SK-1

MPM ADDITION

4.2.12

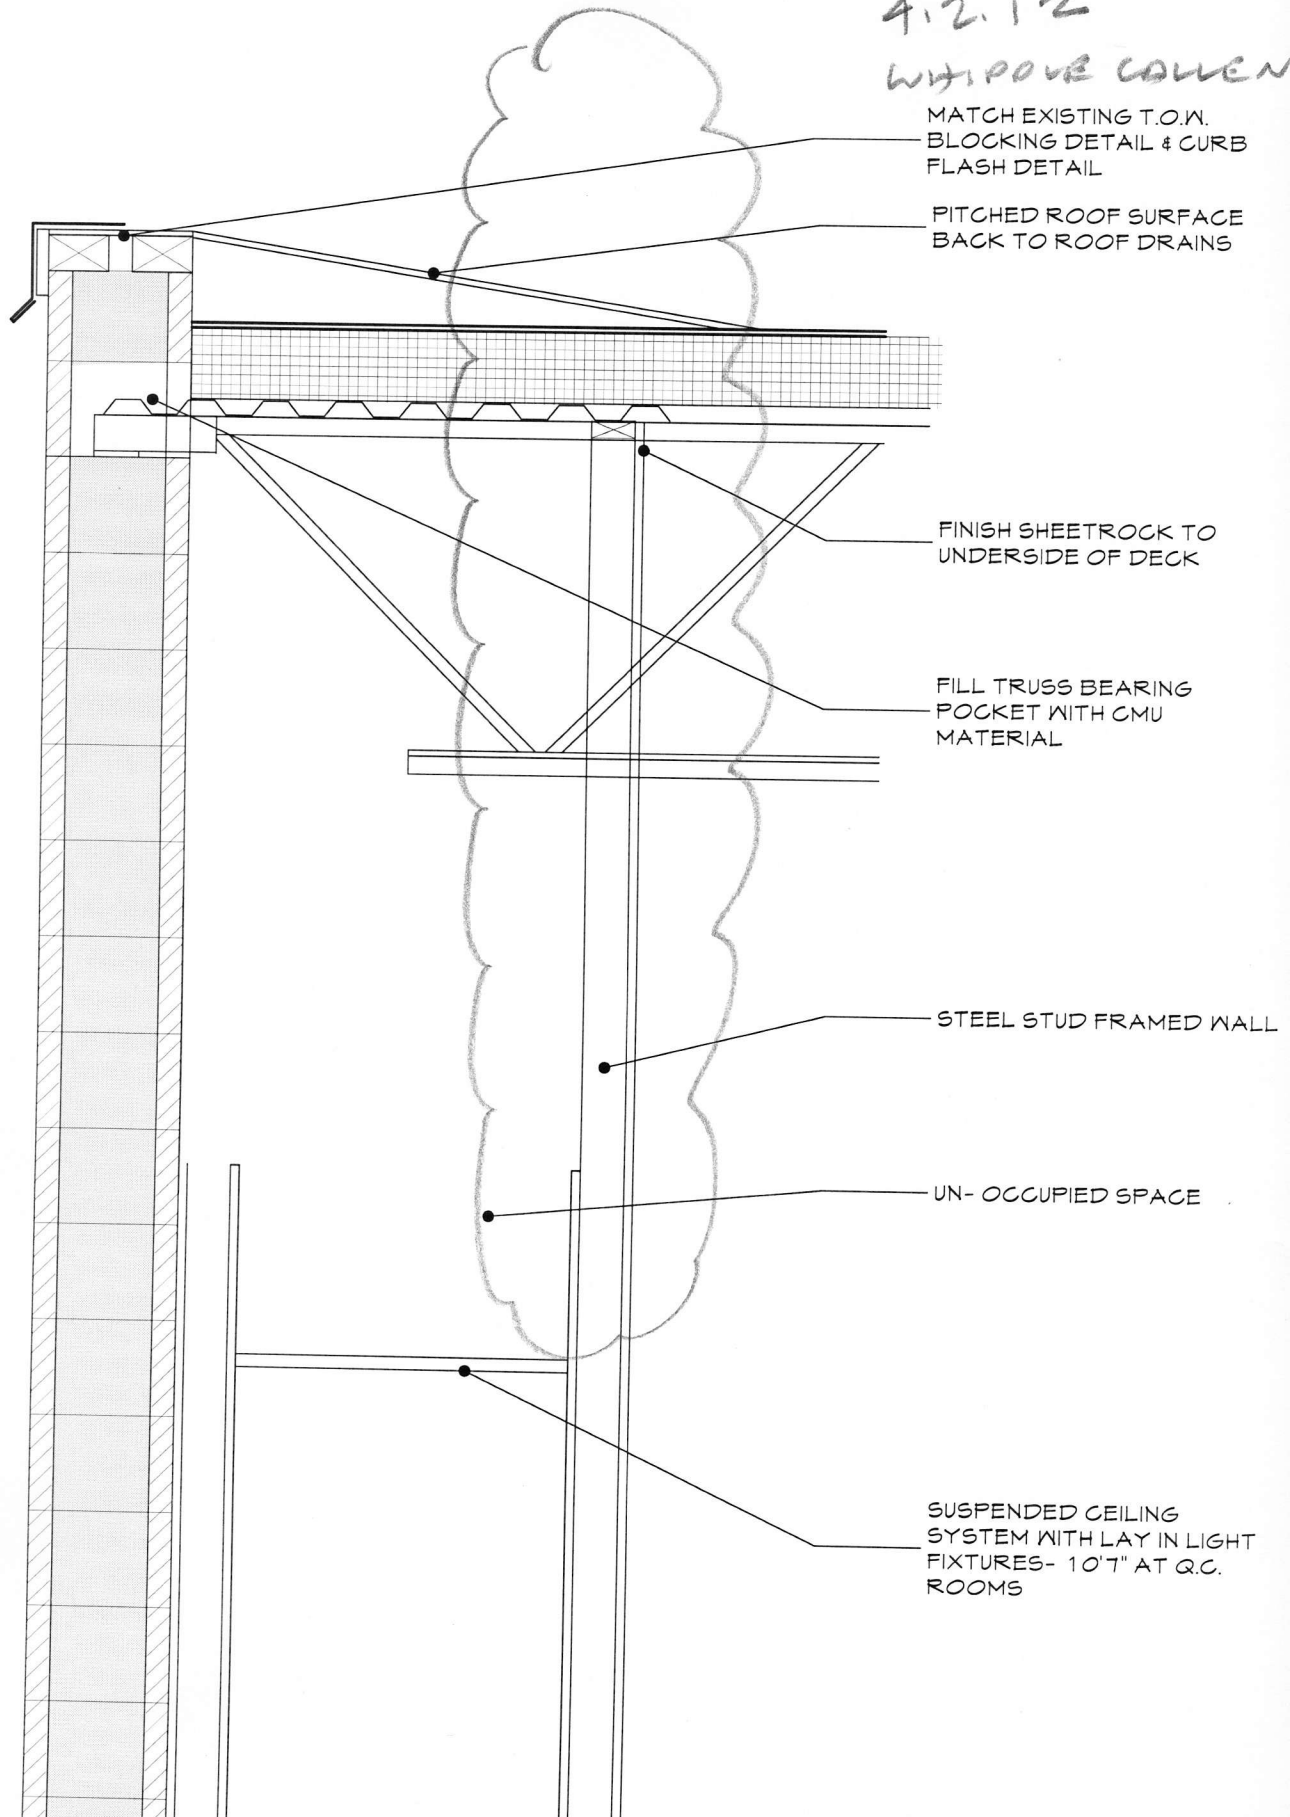
W/1 POOR COLLECTOR

MATCH EXISTING T.O.W.
BLOCKING DETAIL & CURB
FLASH DETAIL

PITCHED ROOF SURFACE
BACK TO ROOF DRAINS

FINISH SHEETROCK TO
UNDERSIDE OF DECK

FILL TRUSS BEARING
POCKET WITH CMU
MATERIAL

STEEL STUD FRAMED WALL

SUSPENDED CEILING
SYSTEM WITH LAY IN LIGHT
FIXTURES- 10'7" AT Q.C.
ROOMS
